RELEASE AND SETTLEMENT AGREEMENT

1. Further Work. Morgan, through its contractor J&K Contracting, L.L.C. ("J&K"), will perform certain repairs to the Project as set forth in Exhibit 1 attached hereto, without cost to Polk County or Ankeny ("Further Work"). Ankeny has prepared a "Revised Set of Plans" which provide the specifications for the Further Work, attached hereto as Exhibit 2 and incorporated as though set forth fully herein. The Further Work will commence on or about July 30, 2018. All

ROCK CREEK LATERAL SANITARY SEWER

Sheet D4.14

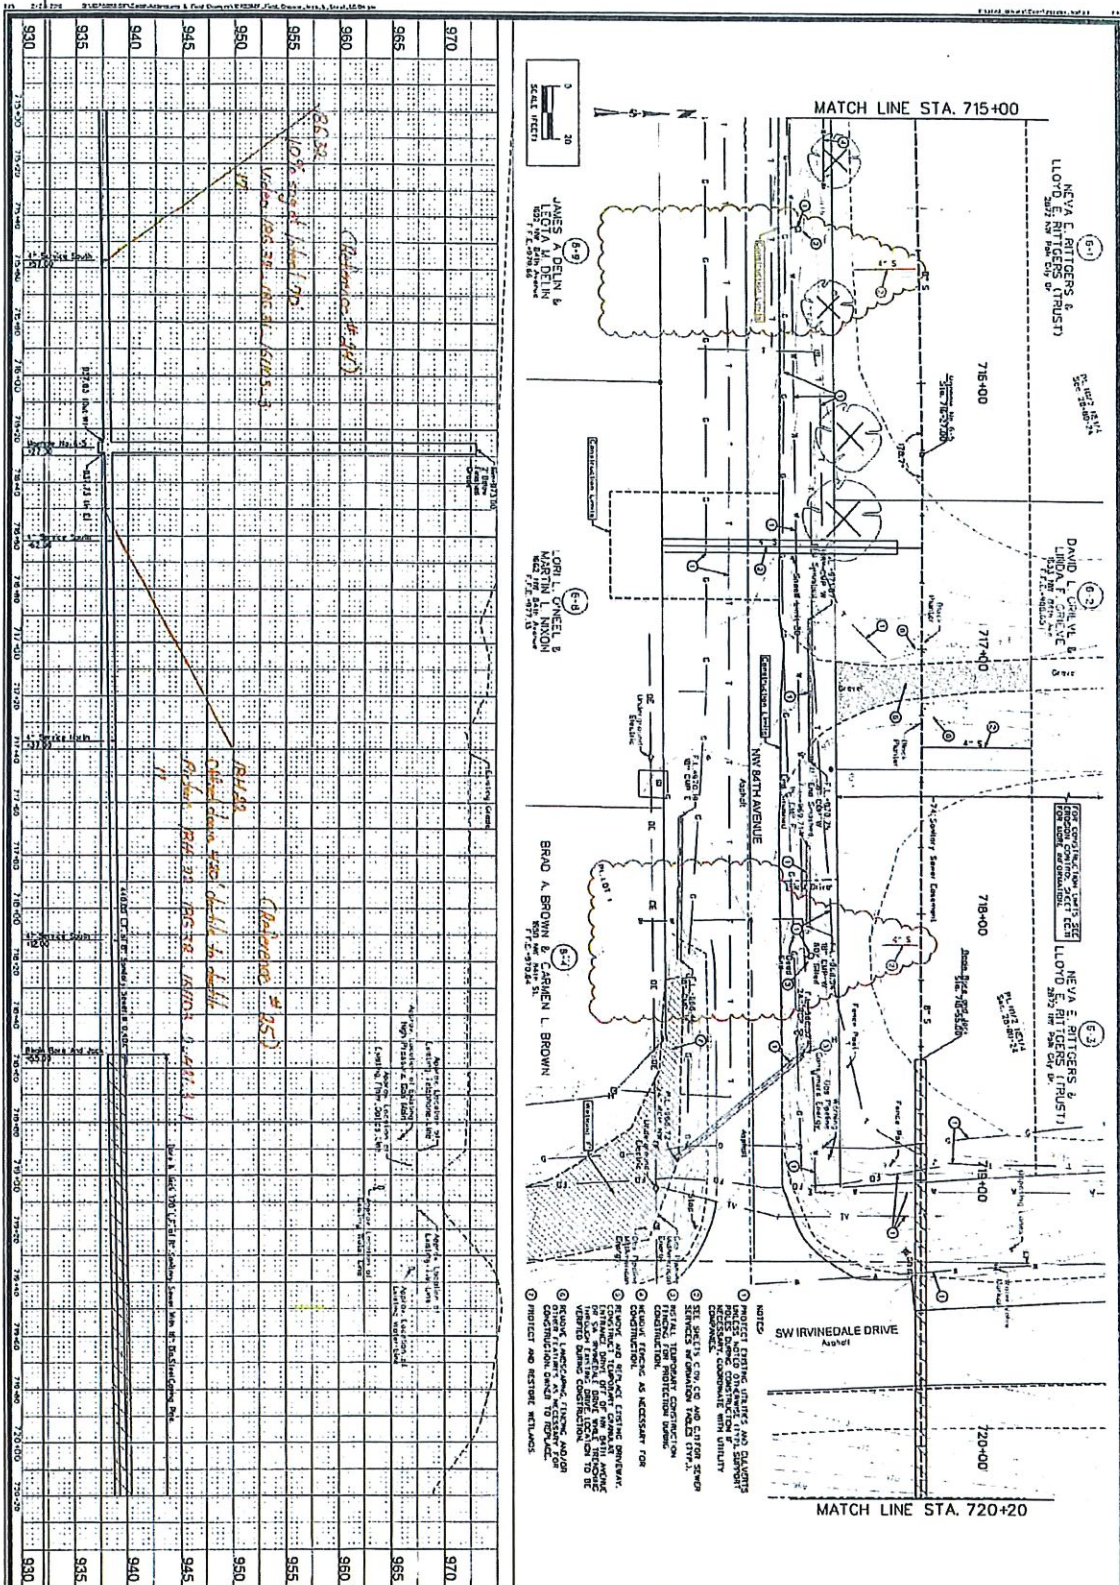
(Sheet D4.14) 17G 95 Plan Number 4-29/4-27 Offset up 167' ductile to PVC

(23) A fix is not warranted at this location. There is no flow line restrictions or infiltration and is functioning. The joint only looks off set because the flow lines match but the inside diameter of the two pipes are not the same, dis-similar pipe, the DIP inside diameter is larger than the truss pipe. OK.
